April 2024 | Final Environmental Impact Report
State Clearinghouse No. 2023010229

GRANT ELEMENTARY SCHOOL CAMPUS MASTER PLAN PROJECT

for Santa Monica-Malibu Unified School District

Figure 3-7b - Proposed Project Site Plan - Phase 2

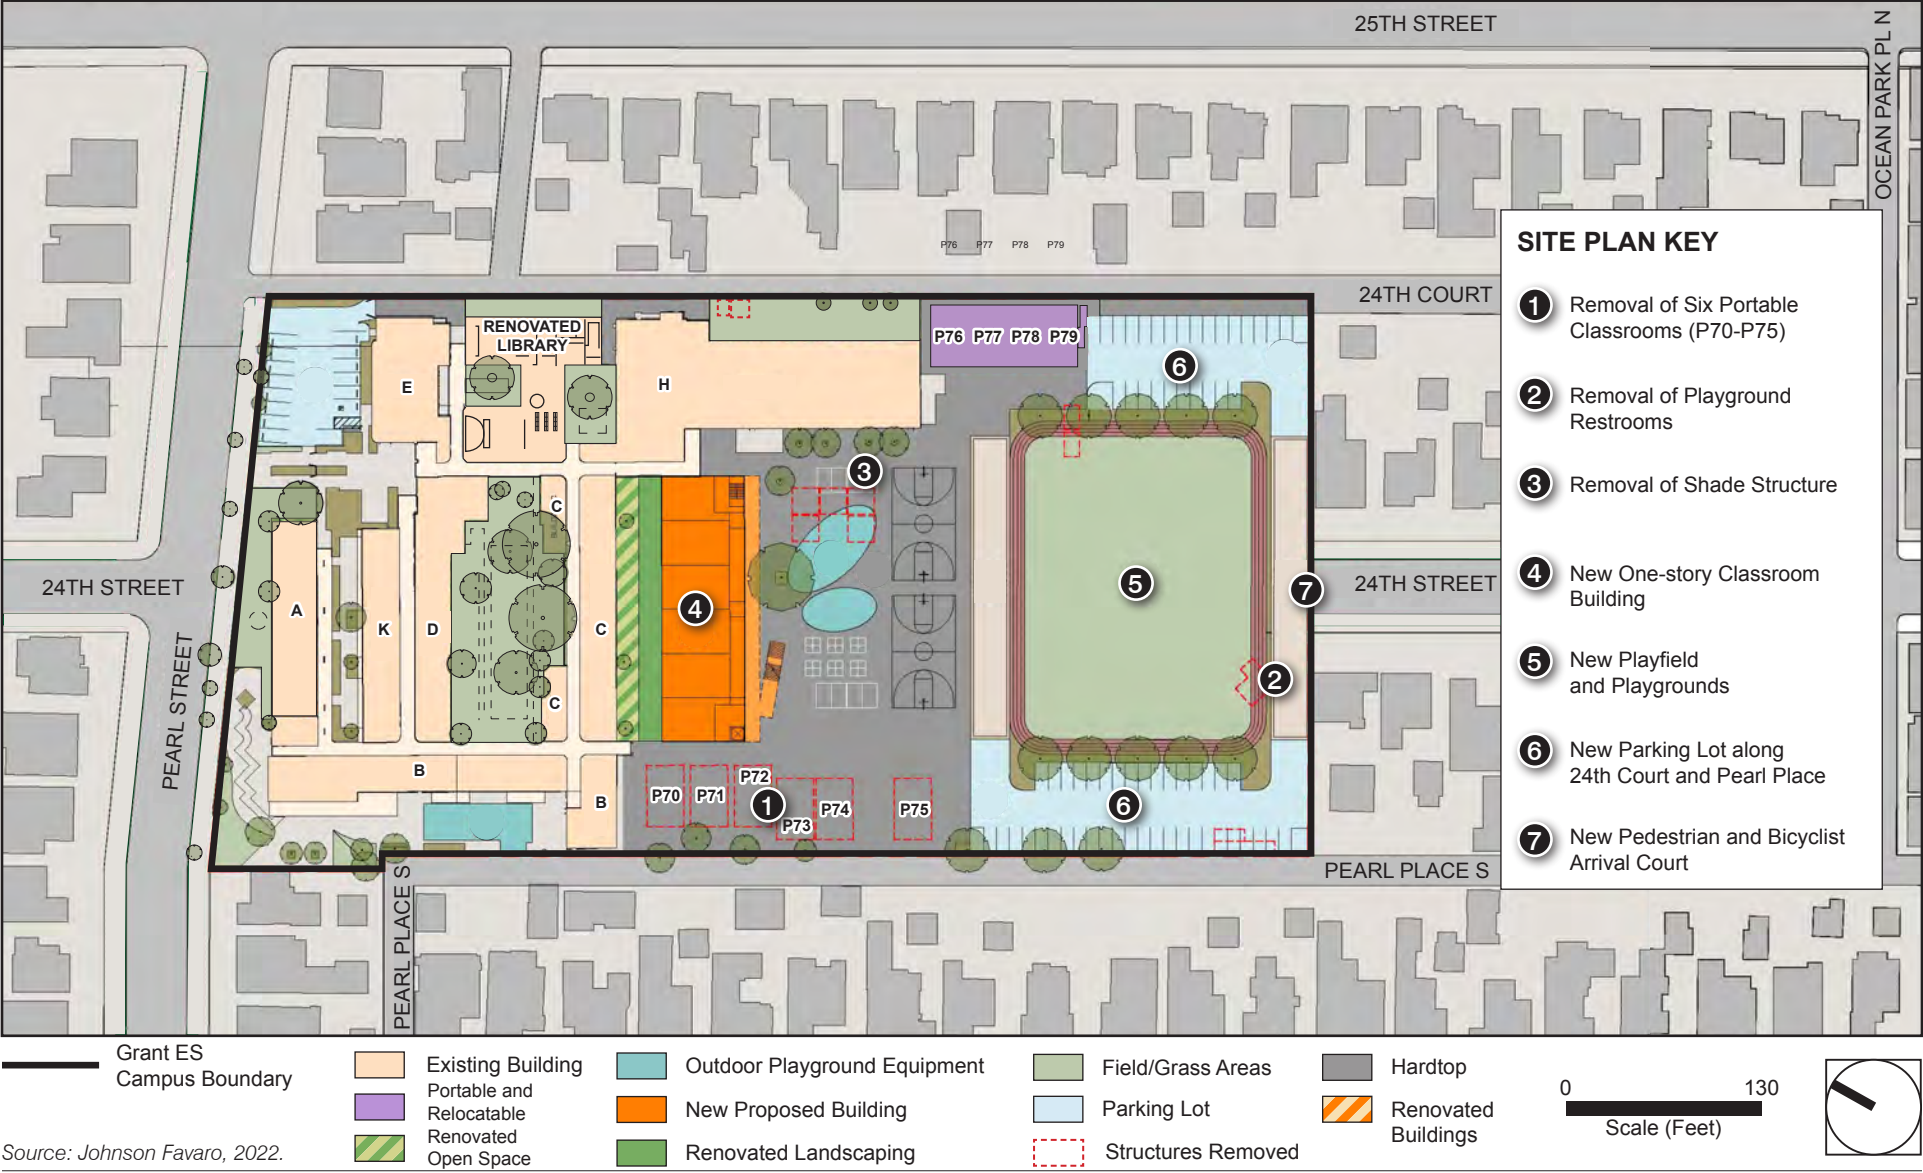
O1-4 The commenter summarizes their request that mitigation measures be added to the DEIR, including an expanded drop-off/pick-up zone for those not using automobiles, no net increase in parking spaces, and the removal of the arrival court from the Proposed Project.

Regarding the request for removal of the arrival court, the arrival court would provide safe access to the campus for students who walk or bike to campus, and arrive from 24th Street, to avoid having to cross vehicular circulation within the new parking lots. The arrival court would not be used to for vehicular drop off/pick up. References to the arrival court in the DEIR have been revised to indicate that the arrival court is intended for pedestrians and bicyclists only, and no vehicles would be allowed, as show in Chapter 3, *Revisions to the DEIR*, of this FEIR.

Figure 3-9 - Design Option, Pearl Street Community Plaza

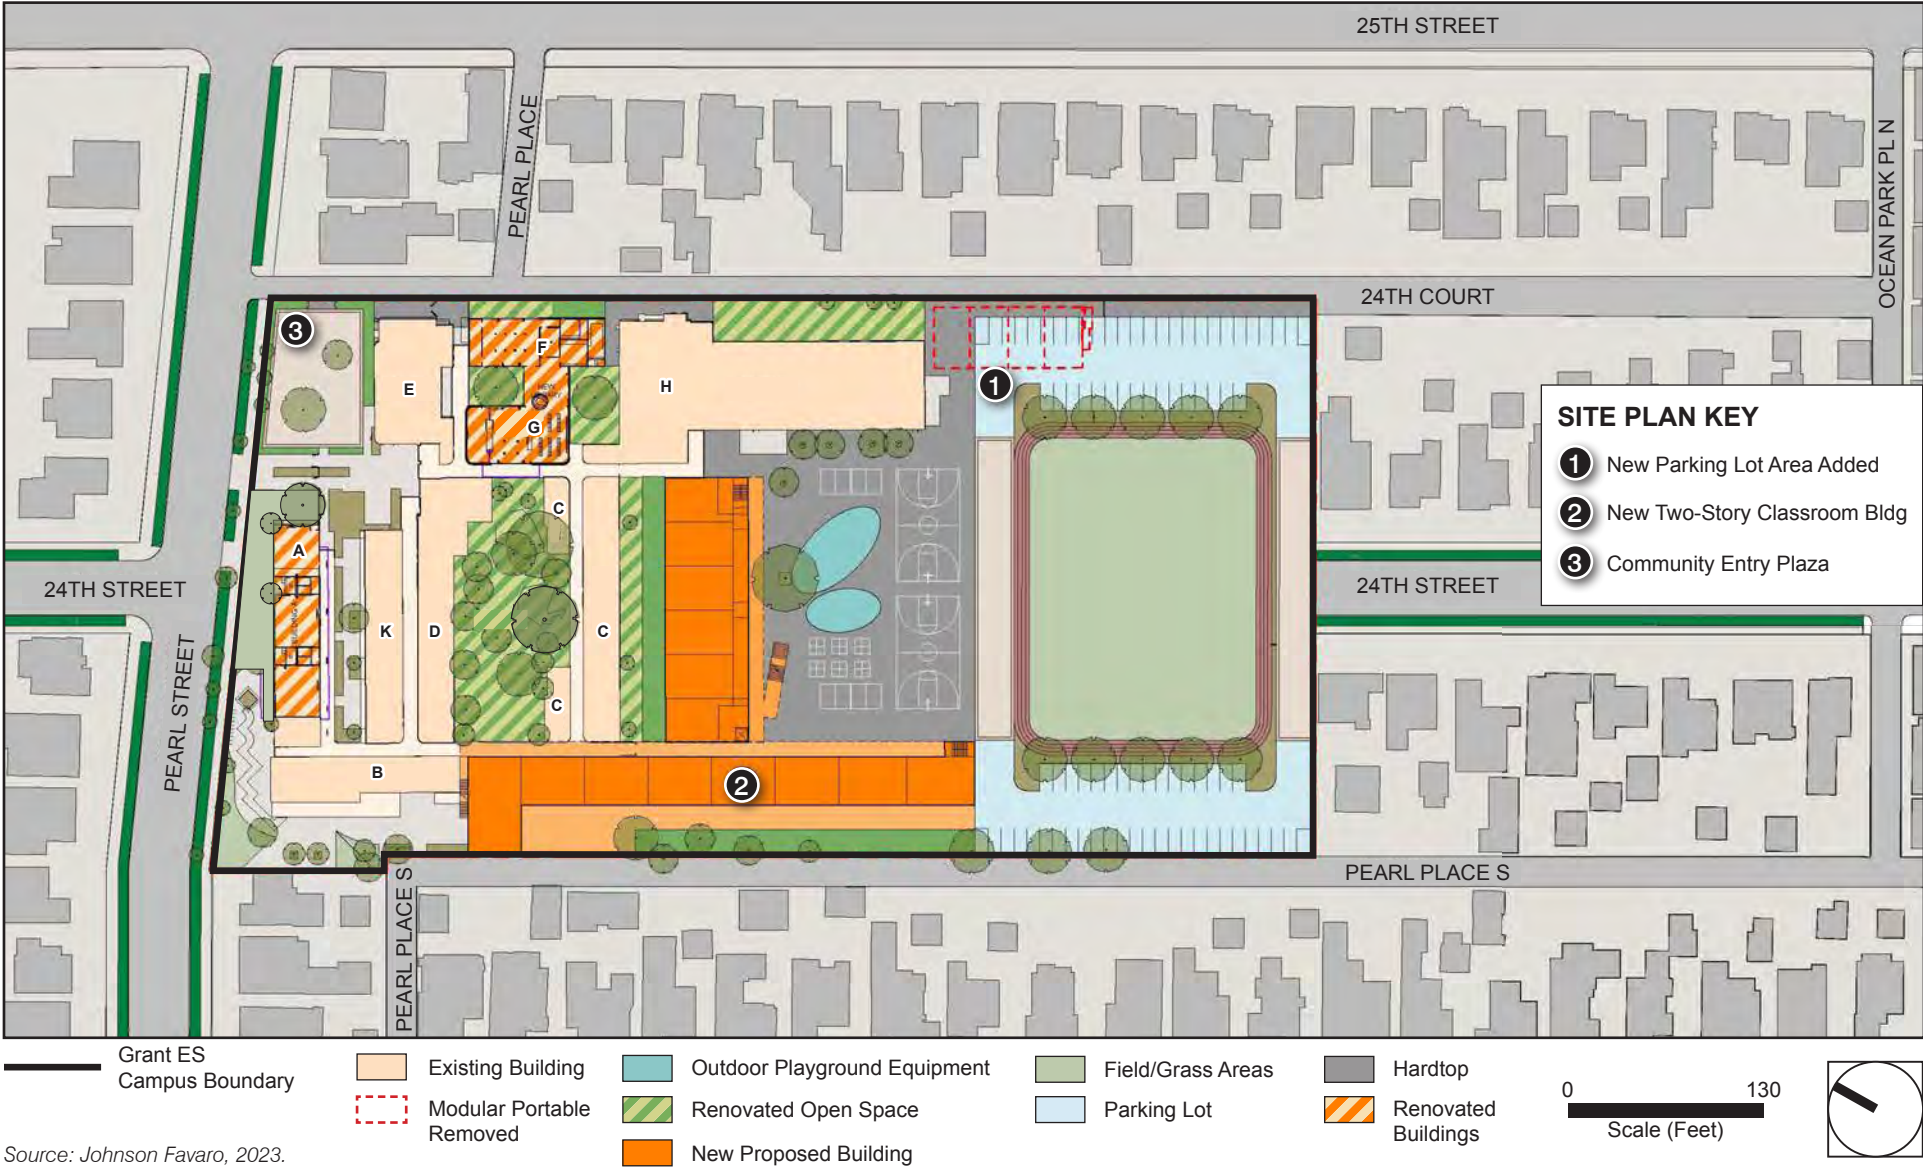
- O1-12 The comment states that the District should evaluate drop-off and pick-up zones and expand the zones for pedestrians and bicyclists that are not using automobiles, and repurposing the Pearl Street parking lot to meet current accessibility needs for cargo bikes and other micro-mobility modes of transportation.

- O1-13 This comment states that any net additional parking spaces should be limited to 14 maximum (offsetting the conversion of the north lot and maintaining net zero parking spaces campus-wide).

As described in comment response O1-4, in response to comments received during the public review period of the DEIR, the District has included a design option in the Proposed Project's Description that would include removal of the administrative parking lot located at the northeast corner of the school, as described in Chapter 3, *Revisions to the DEIR*, of this FEIR. The design option would remove the 14 parking spaces from the existing parking lot during the Phase 3 of the Proposed Project consistent with the commenters request, and implement a new community plaza, which would be accessible to pedestrians and bicyclists via 24th Court (see Figure 3-9, Design Option, Pearl Street Community Plaza, of the FEIR). This additional non-automobile drop-off/pick-up area would offset any reduction in spaces associated with the expansion of student outdoor play areas in Phase 1.

The Proposed Project includes a design option that would repurpose the administrative parking lot located at the northeast corner of the Grant ES campus into a community plaza, as shown in Figure 3-9, *Design Option, Pearl Street Community Plaza*. Implementation of the design option would eliminate all 14 parking spaces on the existing parking lot during Phase 3 of the Proposed Project, reducing overall parking on the campus from 94 to 80 parking spaces. The proposed community plaza would serve as drop-off and pick-up area and would be accessible to pedestrians and bicyclists only, via 24th Court.
